UNITED STATES PATENT AND TRADEMARK OFFICE

APPLICATION NO.	FILING DATE	FIRST NAMED INVENTOR	ATTORNEY DOCKET NO.	CONFIRMATION NO.
09/777,681	02/07/2001	Kazuo Hakamata	Q61216	3338

Office Action Summary

DETAILED ACTION

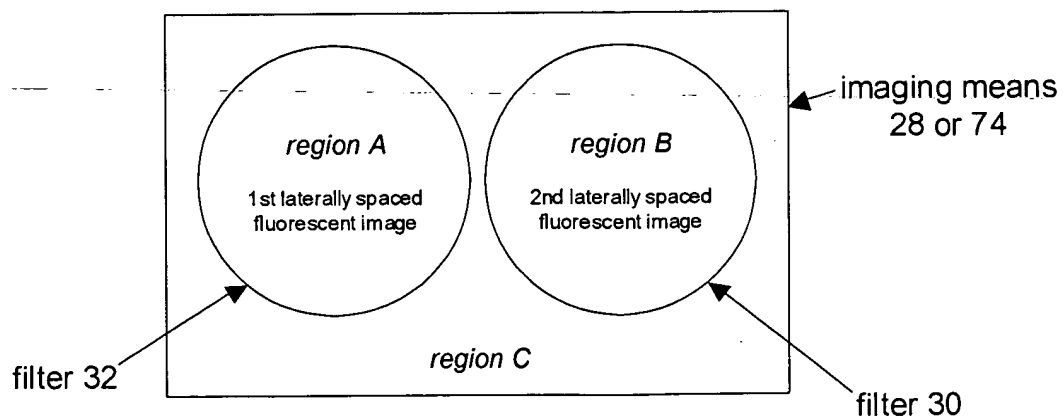
Applicant argues (last two paragraphs on pg. 3 of remarks filed 22 May 2003) that the spatially separate images of Lazarev *et al.* do not relate to different spaces such as an imaging region and a non-imaging region. Examiner respectfully disagrees. It should be noted that two regions of the imaging means are designated as a fluorescence imaging region and a non-imaging region. The fluorescence imaging region is utilized for the imaging of the fluorescence and the non-imaging region is a region other than the fluorescence imaging region, wherein the non-imaging region comprises a region where the fluorescence is not received. As discussed above, the scope of the claims encompasses a non-imaging region having a first region where the fluorescence is not received and a second region where the fluorescence is received. Thus region A and C (as illustrated above) can be designated as a non-imaging region (as defined in the claims) when region B (as illustrated above) is designated as a fluorescence imaging region.

Applicant than argues (second paragraph on pg. 4 of remarks filed 22 May 2003) designating only area 32 instead of areas 30 and 32 represents a shift in position that provides a tacit recognition that the prior analysis includes fundamental flaws. Examiner respectfully disagrees. As discussed above, the scope of the claims encompasses a non-imaging region having a first region where the fluorescence is not received and a second region where the fluorescence is received. Thus region C (as illustrated above) can be designated as a non-imaging region (as defined in the claims) when regions A and B (as illustrated above) are designated as a fluorescence imaging

region. Therefore region A, region B, or both can be designated as the fluorescence imaging region (as defined in the claims).

Applicant further argues (last paragraph on pg. 4 of remarks filed 22 May 2003) that the non-imaging region cannot include two regions since the sensor obtains two fluorescent images. Examiner respectfully disagrees. As discussed above, the scope of the claims encompasses a non-imaging region having a first region where the fluorescence is not received and a second region where the fluorescence is received. Thus region C (and optional either region A or region B) can be designated as the non-imaging region (as defined in the claims).

unimportant pixels (e.g., pixels falling in region C illustrated above) as taught by Wilder *et al.*

falling in region C illustrated above) in the invention of Lazarev *et al.* are *a priori* known as unimportant pixels since region C is defined by the filters 30 and 32 and it is regions A and B that contain the fluorescent images. Therefore, it would have been obvious to one having ordinary skill in the art that the *a priori* known unimportant pixels (e.g., pixels falling in region C illustrated above) in the apparatus of Lazarev *et al.* are prevented from being read, in order to minimize the time consumed in reading unimportant pixels as taught by Wilder *et al.*
